CITY OF MINNETONKA  
PLANNING COMMISSION  
June 1, 2023

**Planning Commission Agenda**  
**June 1, 2023**  
**6:30 p.m.**

<b>Brief Description</b>	Items concerning Walser Kia at 15700 and 15724 Wayzata Blvd:  <ol style="list-style-type: none"><li>1. Master development plan;</li><li>2. Site and building plan review, with expansion permits and variances;</li><li>3. Floodplain and wetland alteration permits;</li><li>4. Conditional use permit, with variance; and</li><li>5. Preliminary and final plats.</li></ol>
<b>Recommendation</b>	Recommend the city council adopt the resolution denying the proposal.

**UTILITY PLAN**

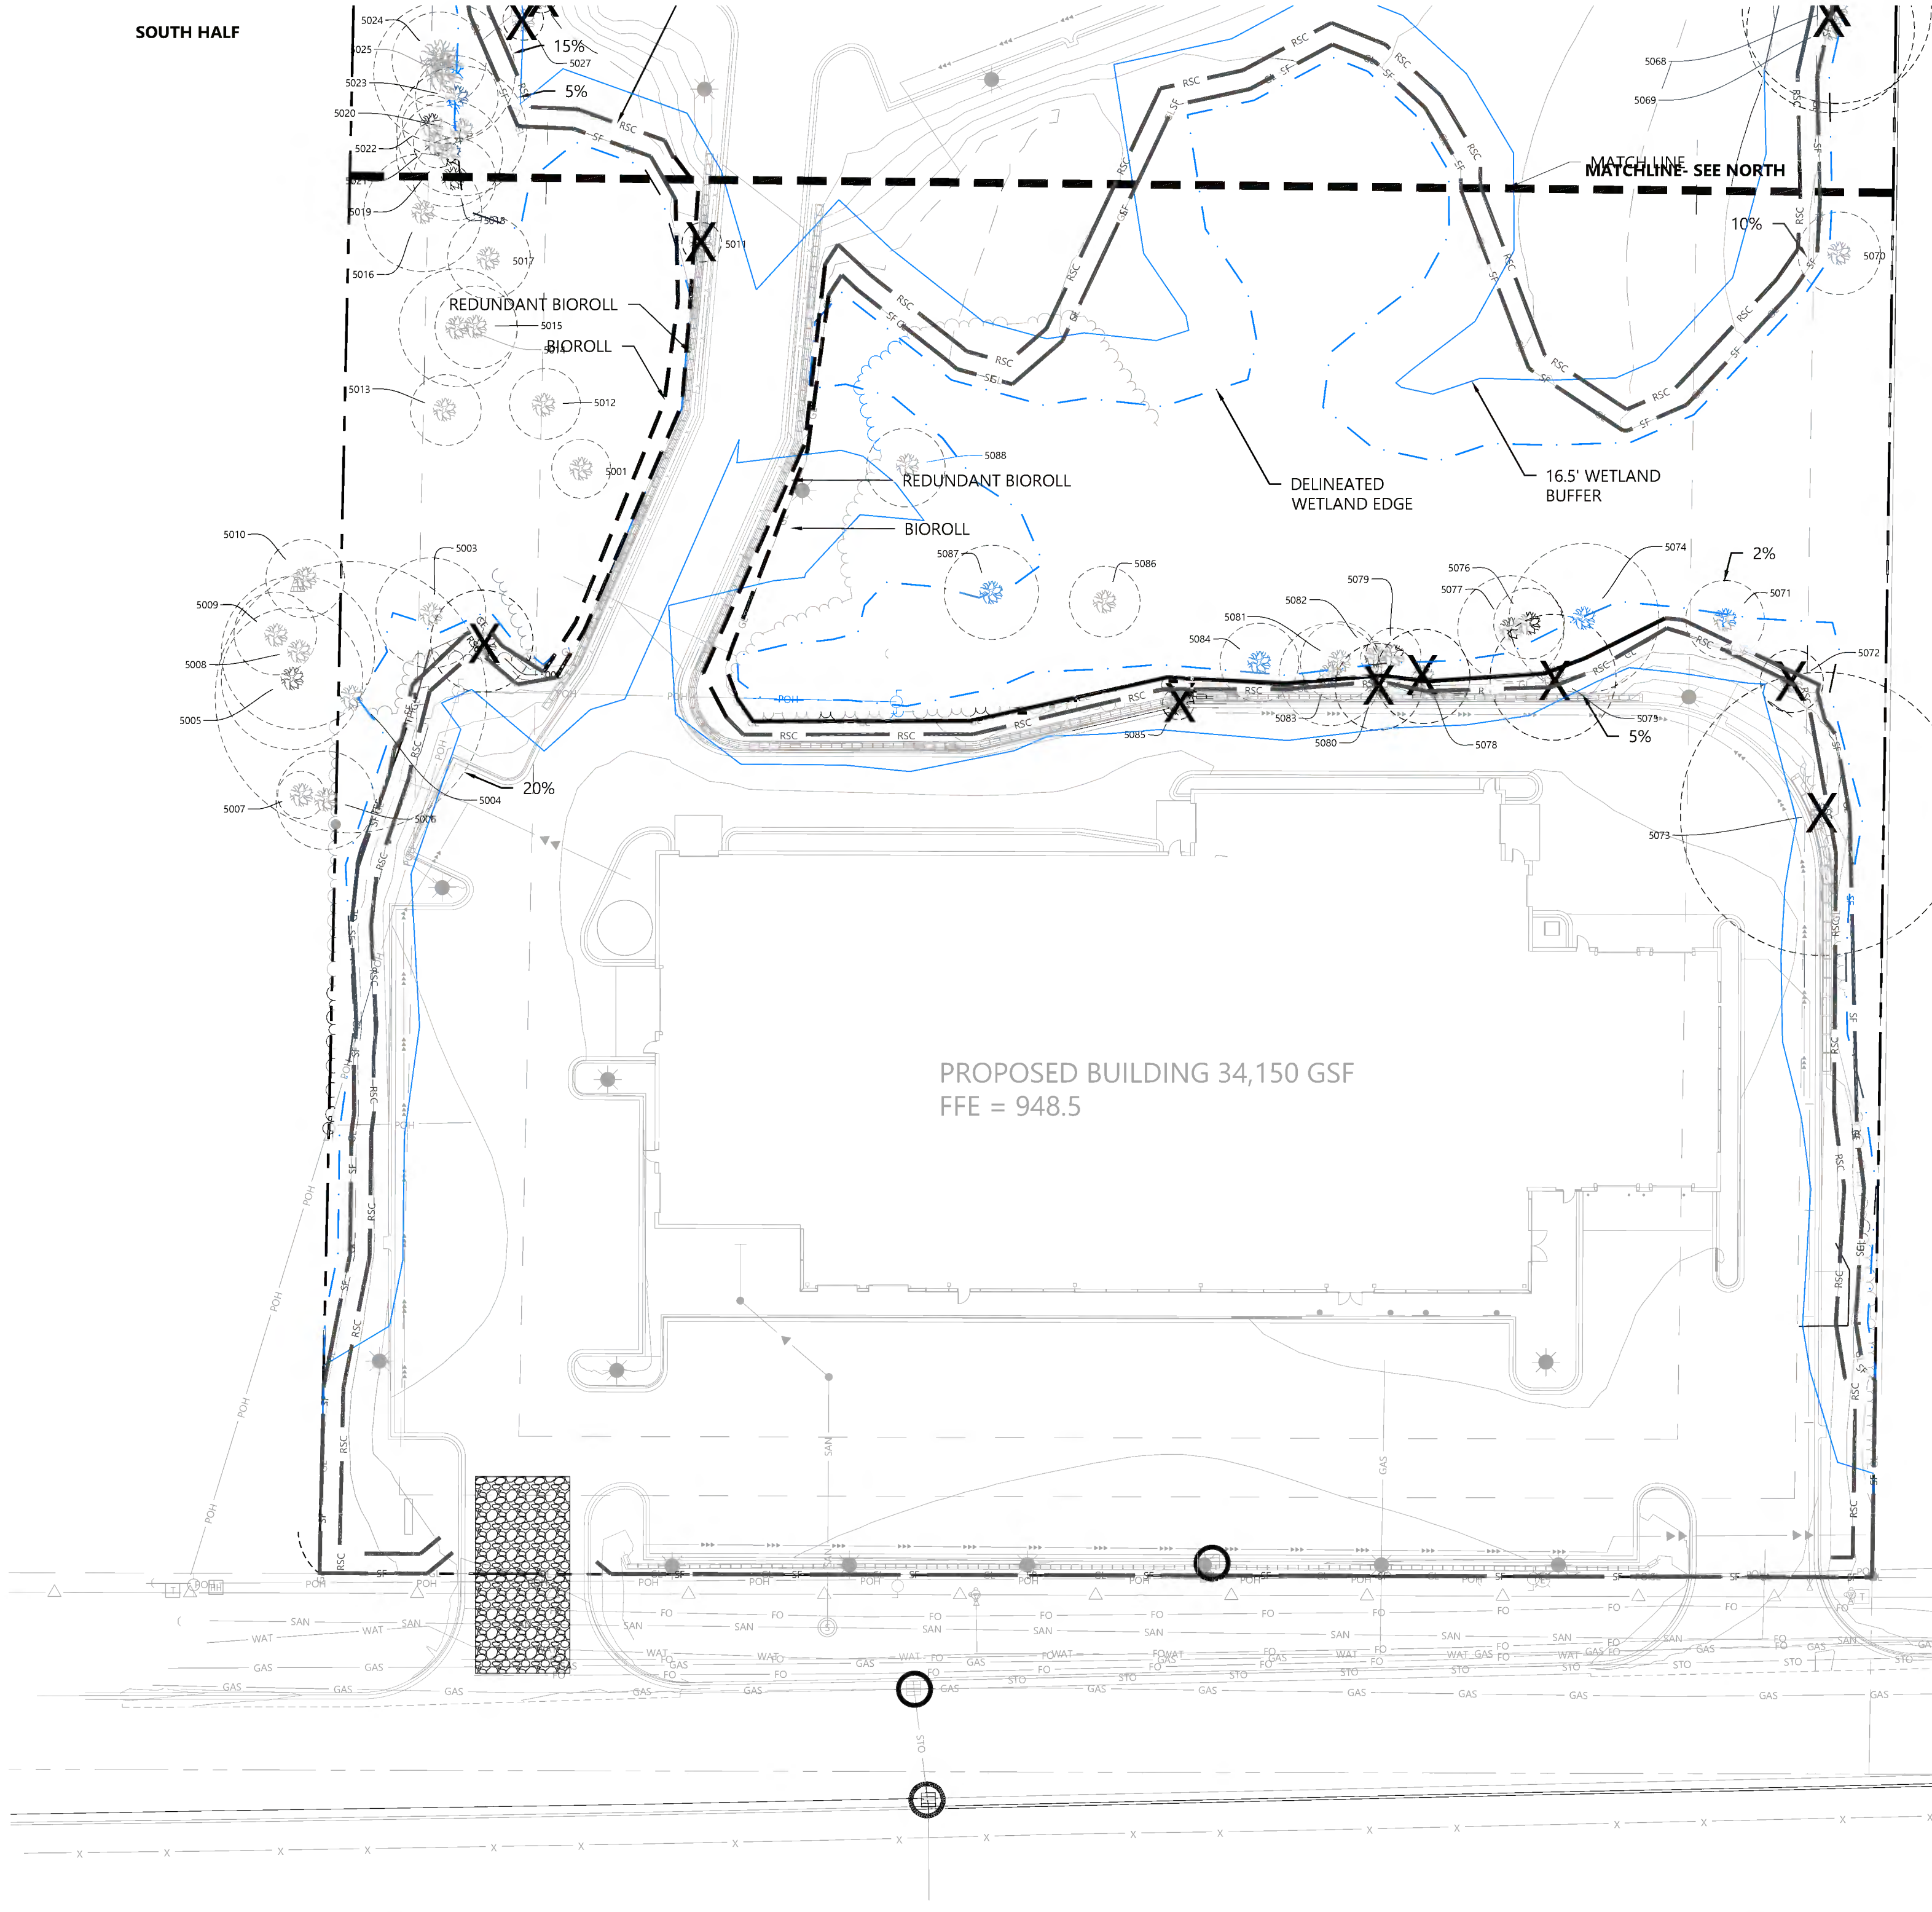
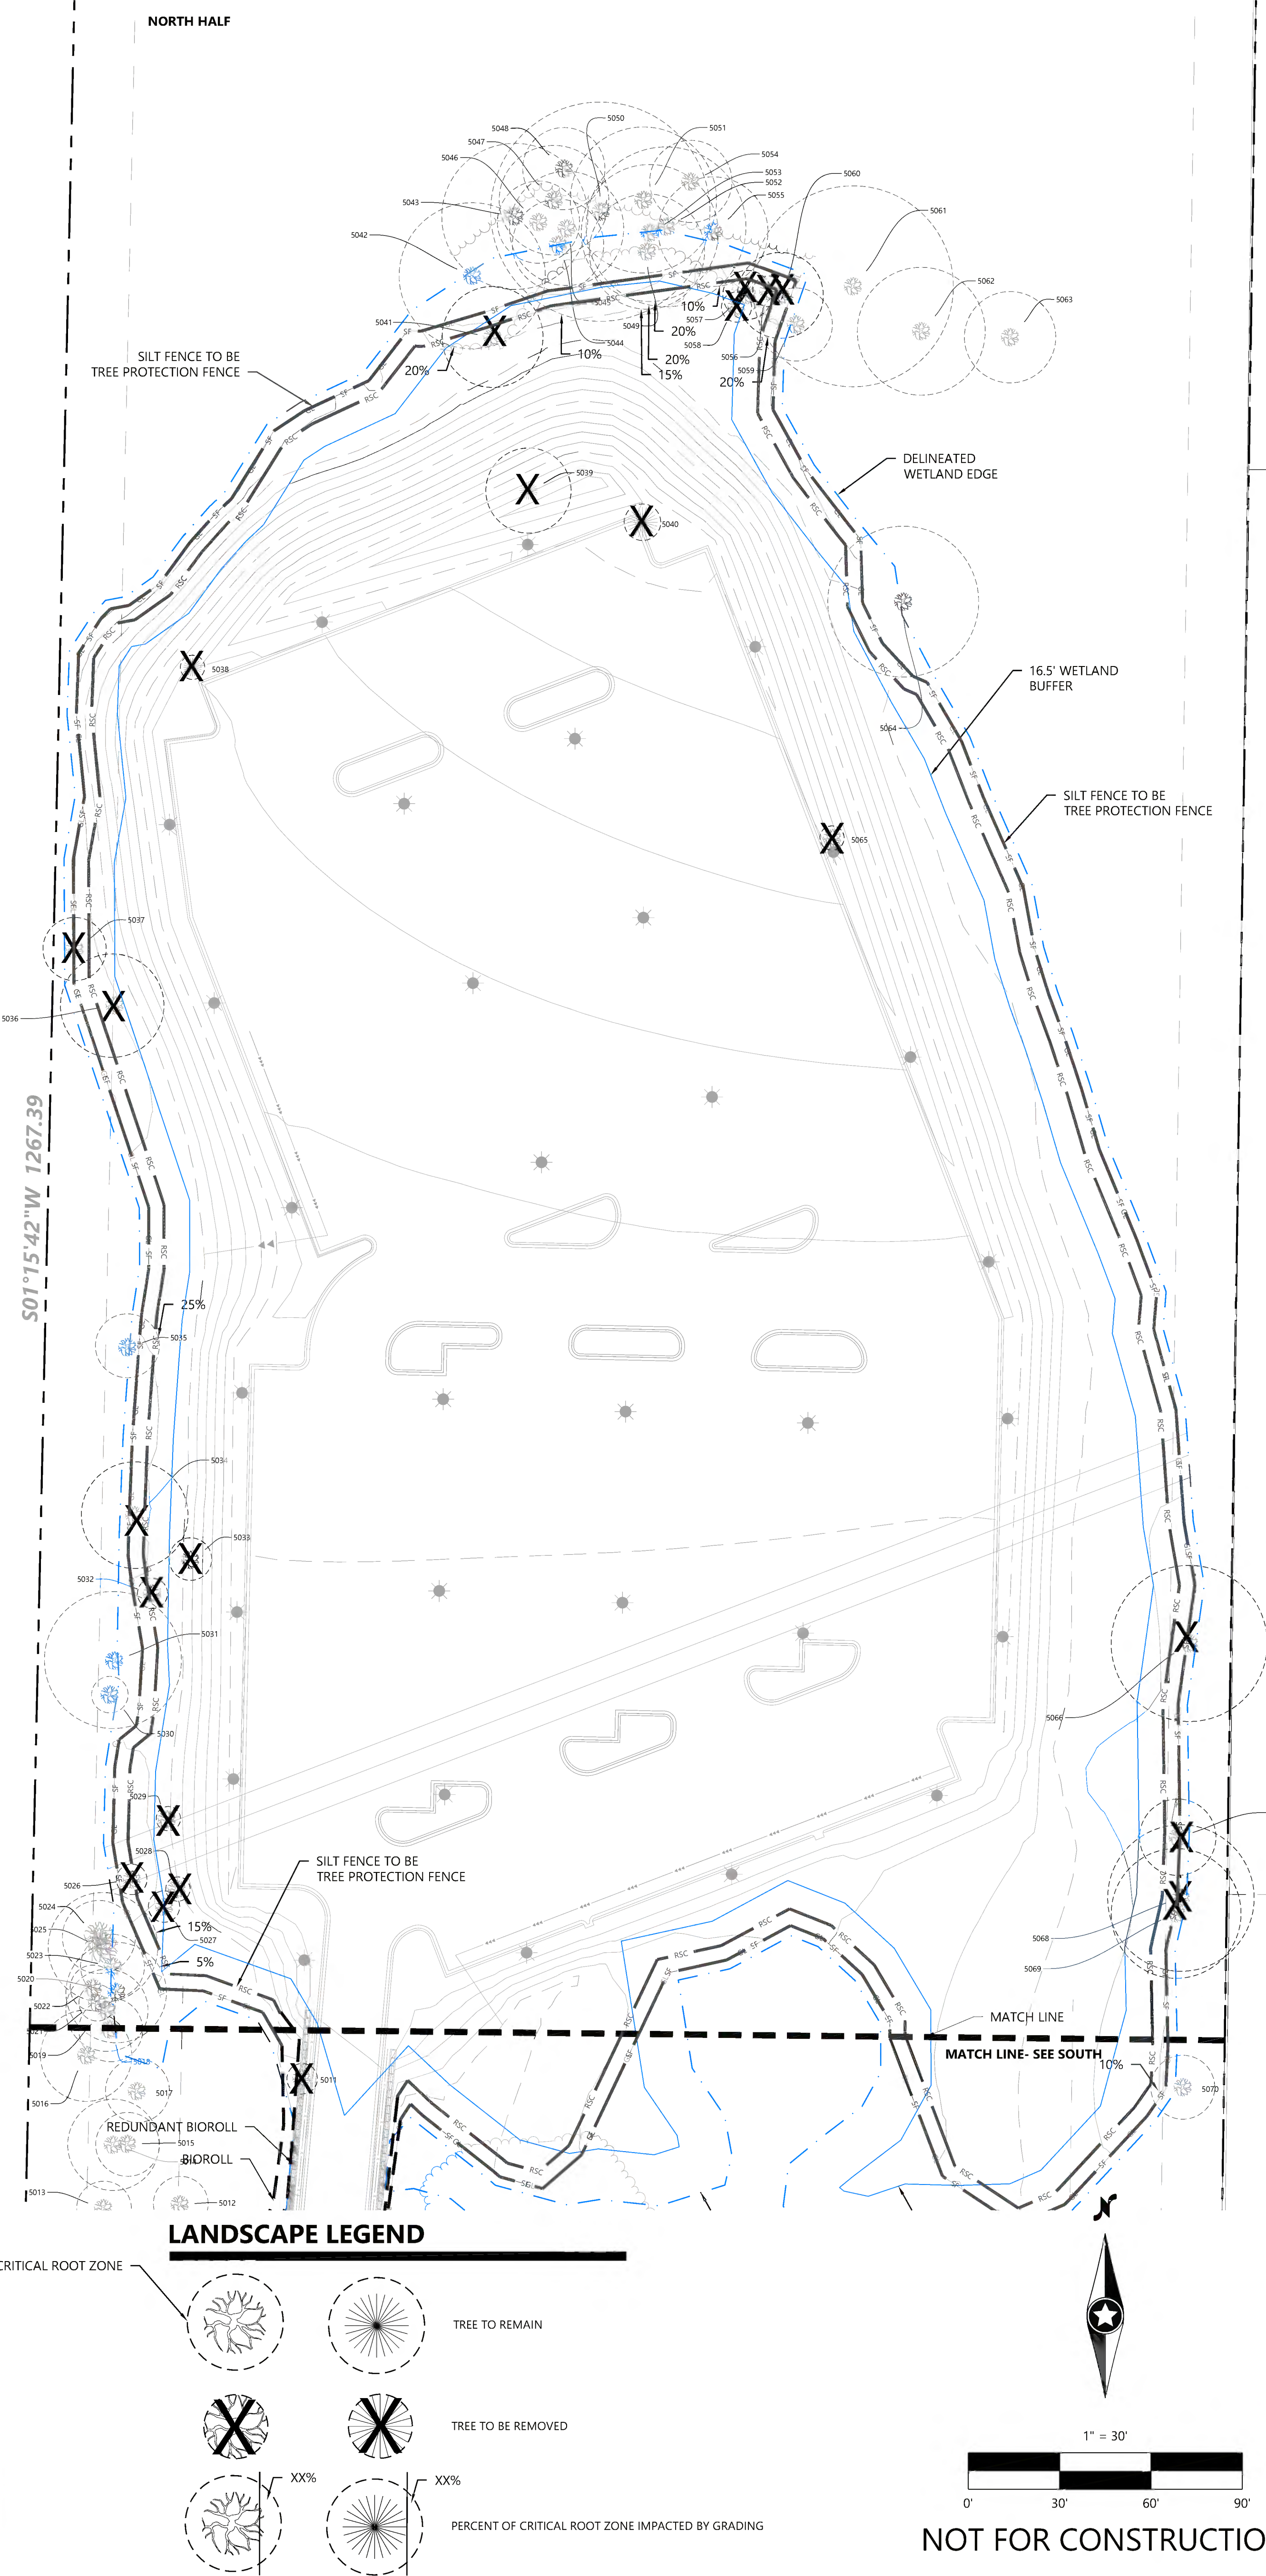
- The full tree inventory is not reflected on the grading plan. The plan only shows the trees proposed to remain. *Noted. The existing trees have been added to the overall grading plan, Sheet C300 for reference.*
- Tree removal thresholds are not calculated correctly. The tree ordinance allows the removal of up to 35% of high-priority trees on the site and 50% of the significant trees. There are no exclusions for where these trees are located. The “basic tree removal” exclusion is for mitigation, not removal. In other words, trees removed in this area are counted in removals but do not need to be mitigated. Staff review of the plans suggests:

*Response: The tree removals and % of total for each category (High Priority and Significant) have been updated per city comments. See information below and landscape plan Sheet L100.*
